The Road to Licensure and Beyond

The Road to Licensure and Beyond
Sample Graphic Vignette Problems

Evaluating Your Sample Solutions

Sample Problem 1
Solution 12 of 12

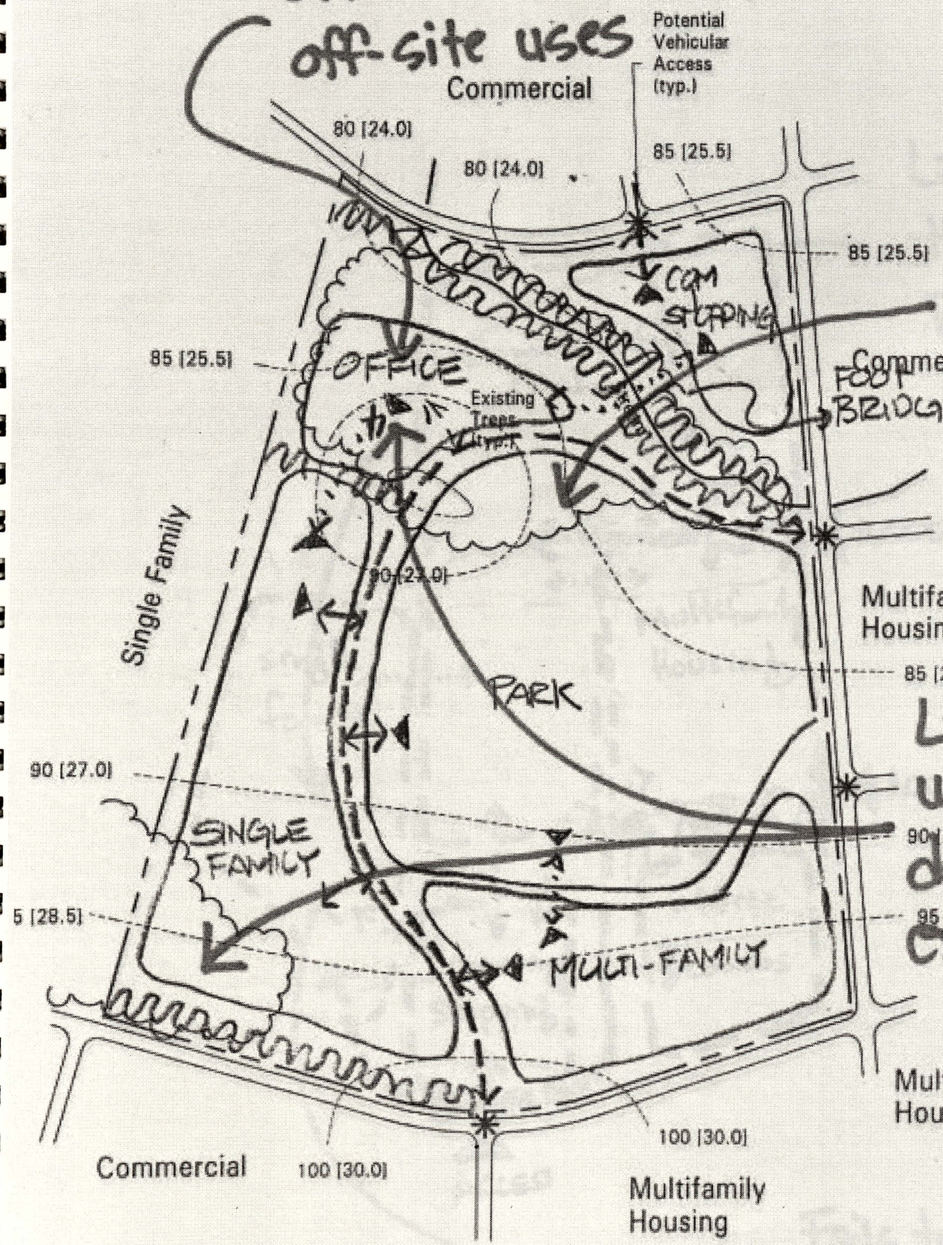
Office does not relate to off-site uses

Solutions are not significantly different

Land use unnecessarily destroys ex. trees

Sample Problem 2
Solution 2 of 12

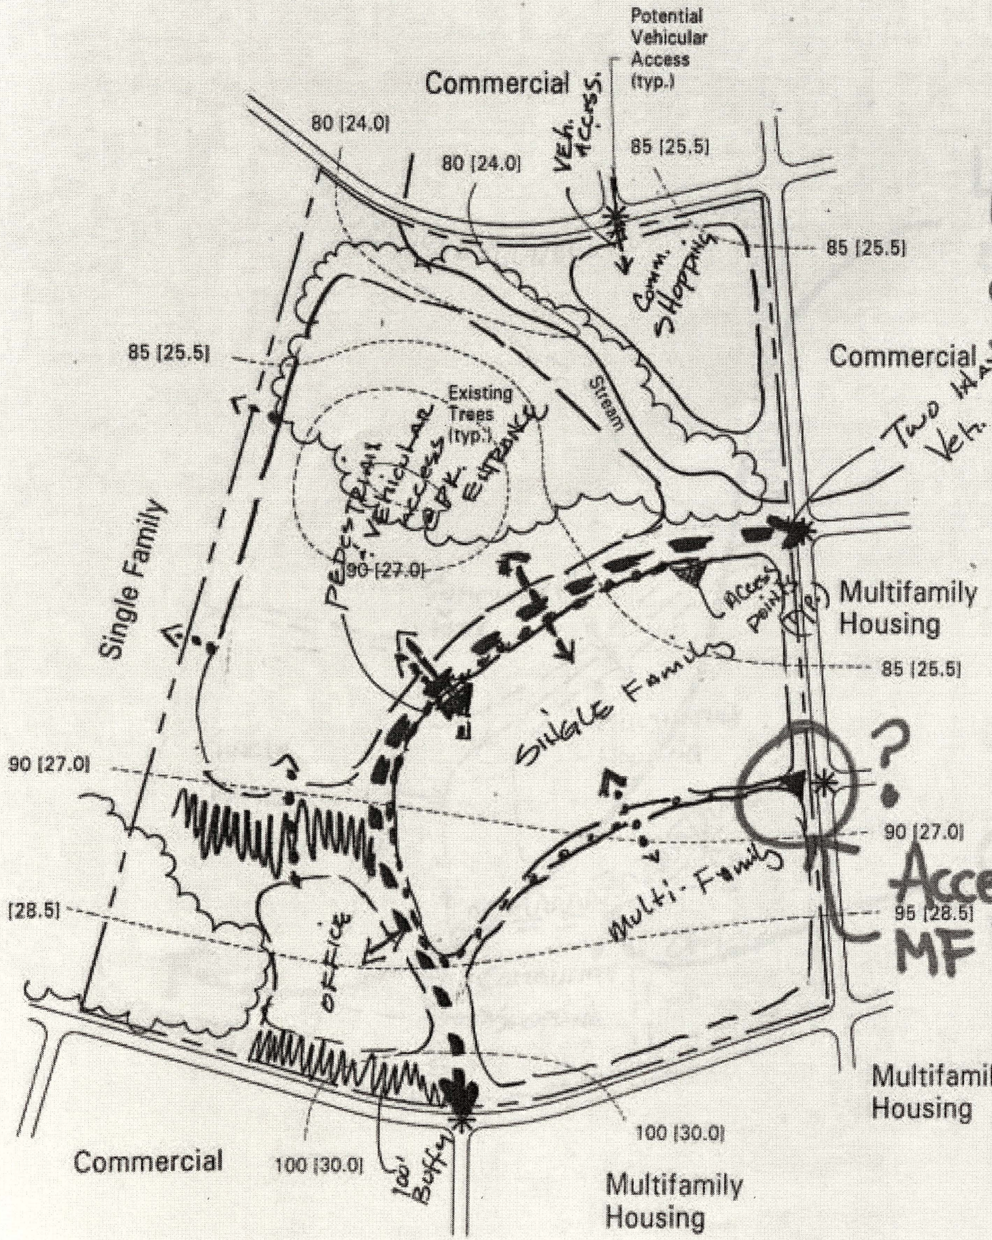
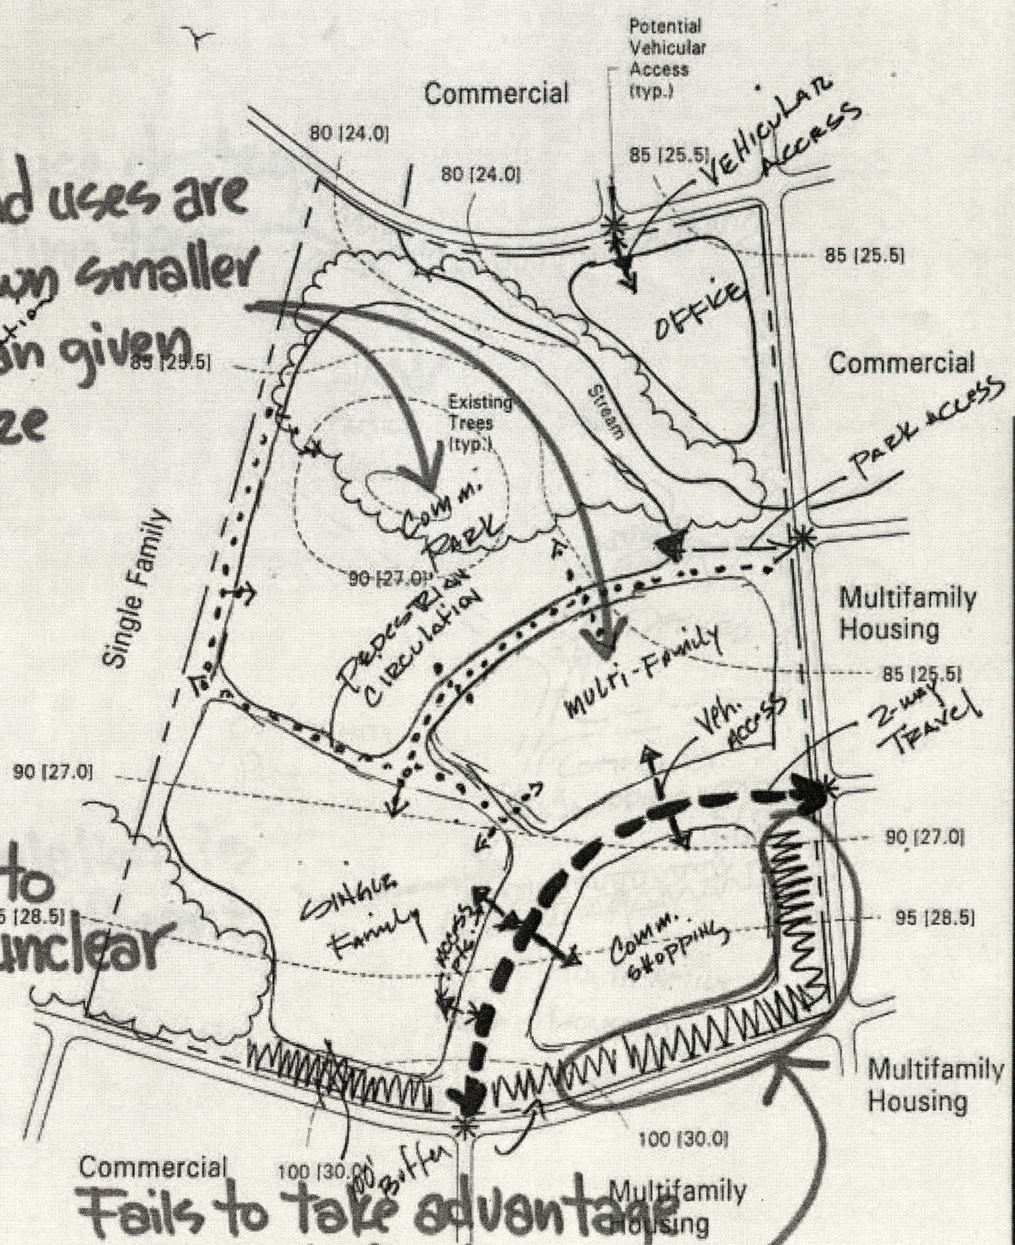
Land uses are drawn smaller than given size

Two way Veh. circulation

Access to MF is unclear

Fails to take advantage of street frontage

Sample Problem 2
Solution 3 of 12

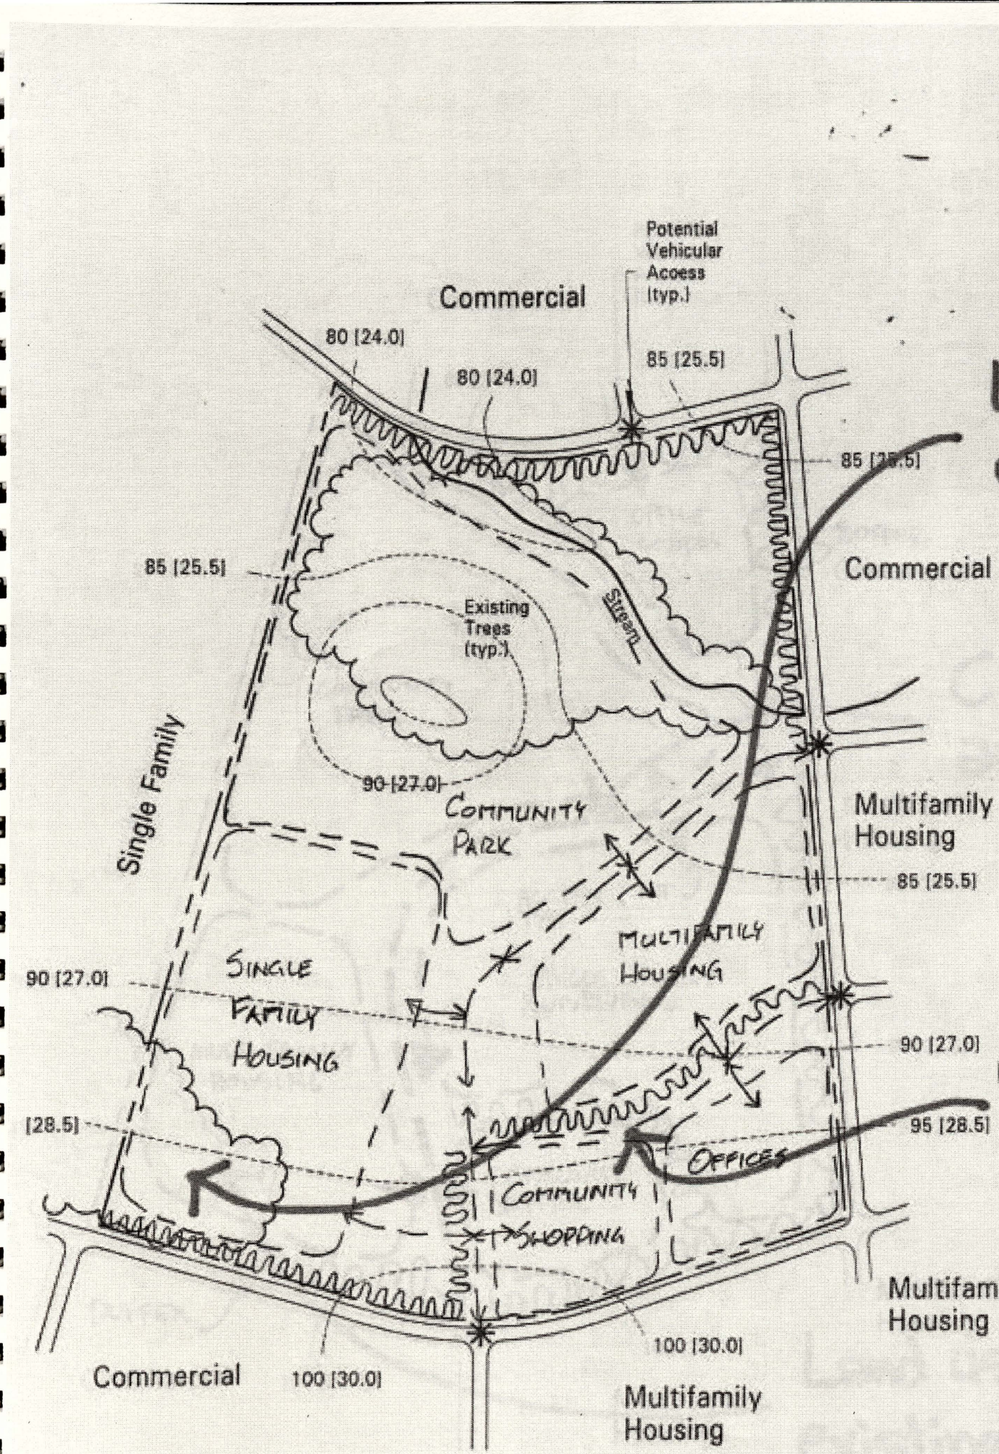
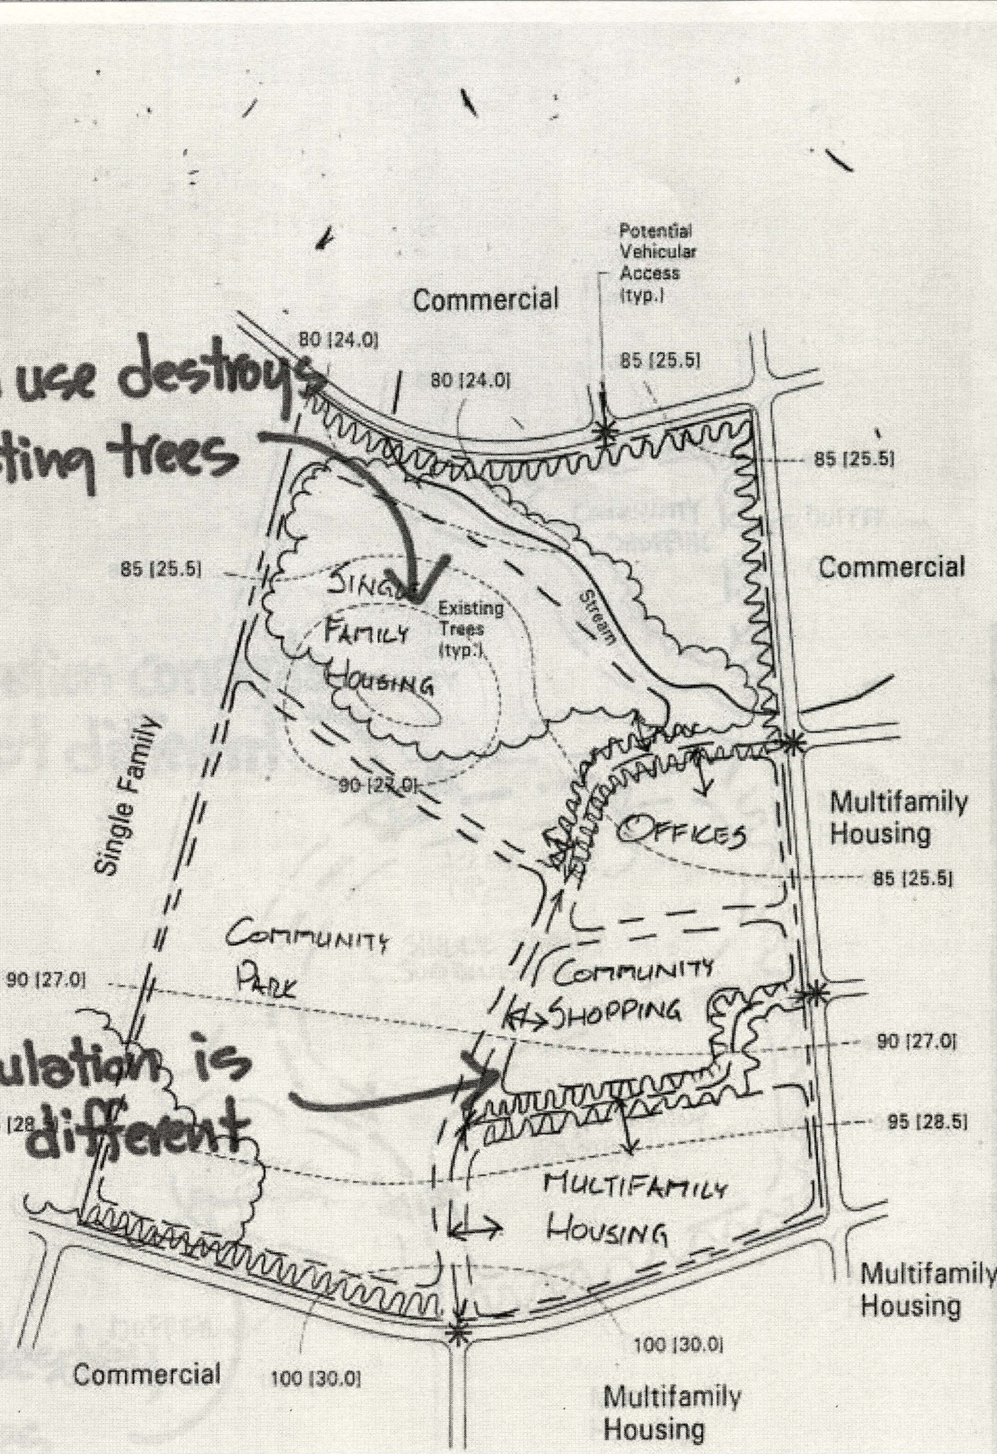
Land use destroys existing trees

Circulation is not different

Sample Problem 2
Solution 4 of 12

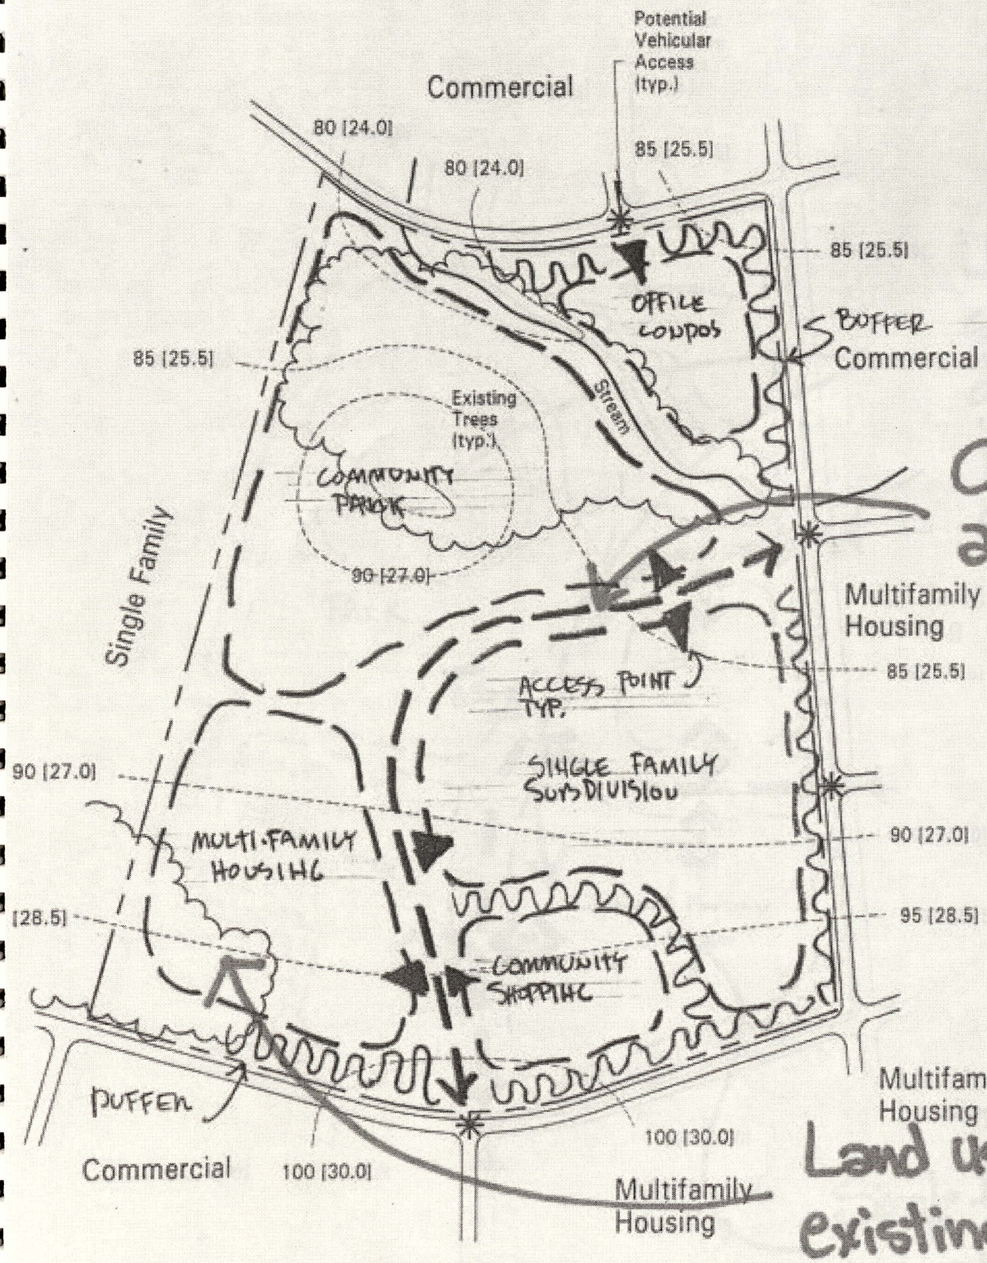
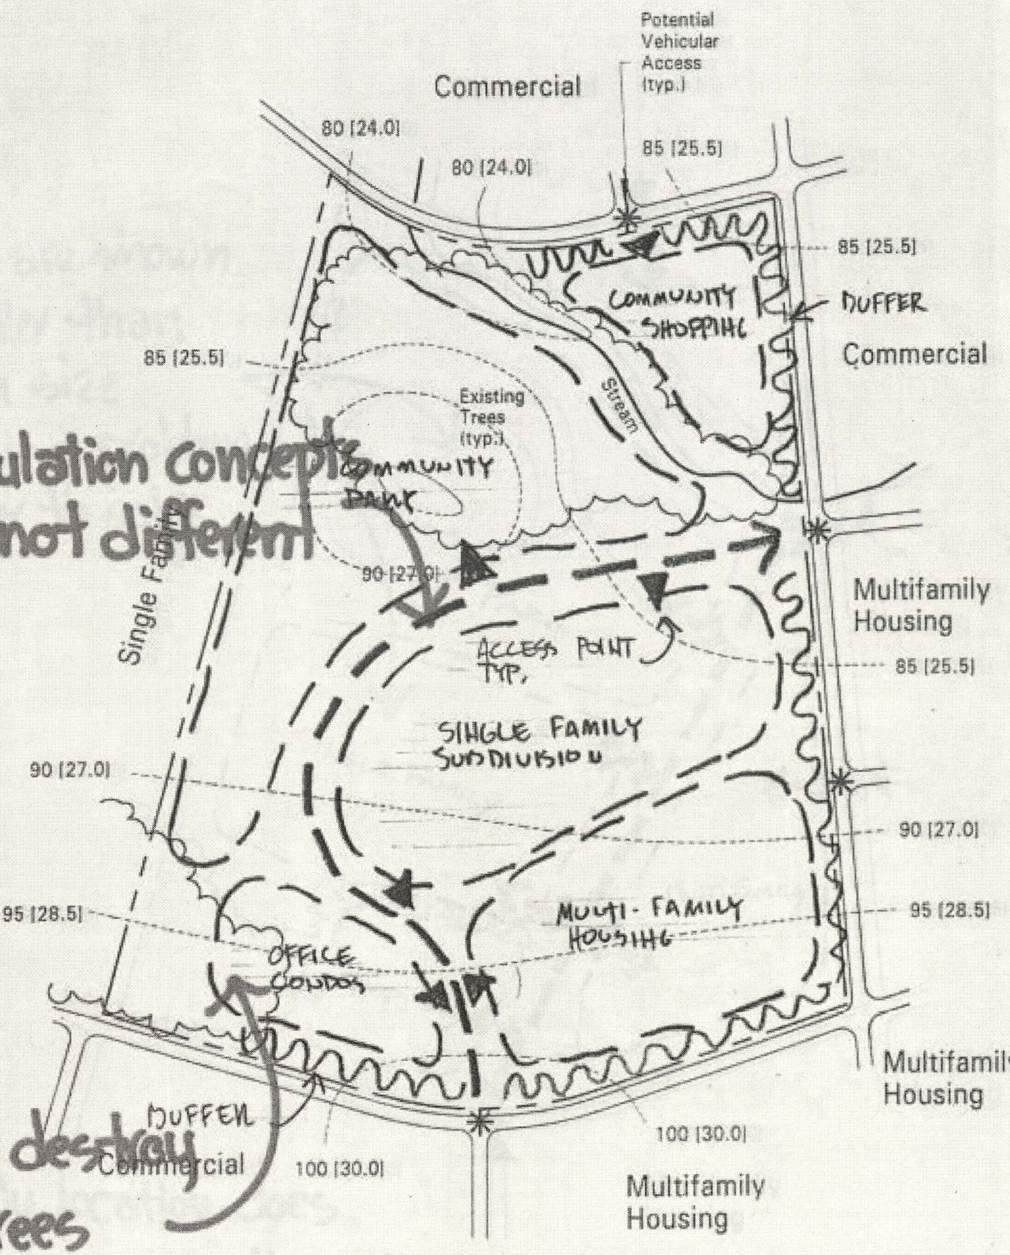
Circulation concepts are not different

Land uses destroy existing trees
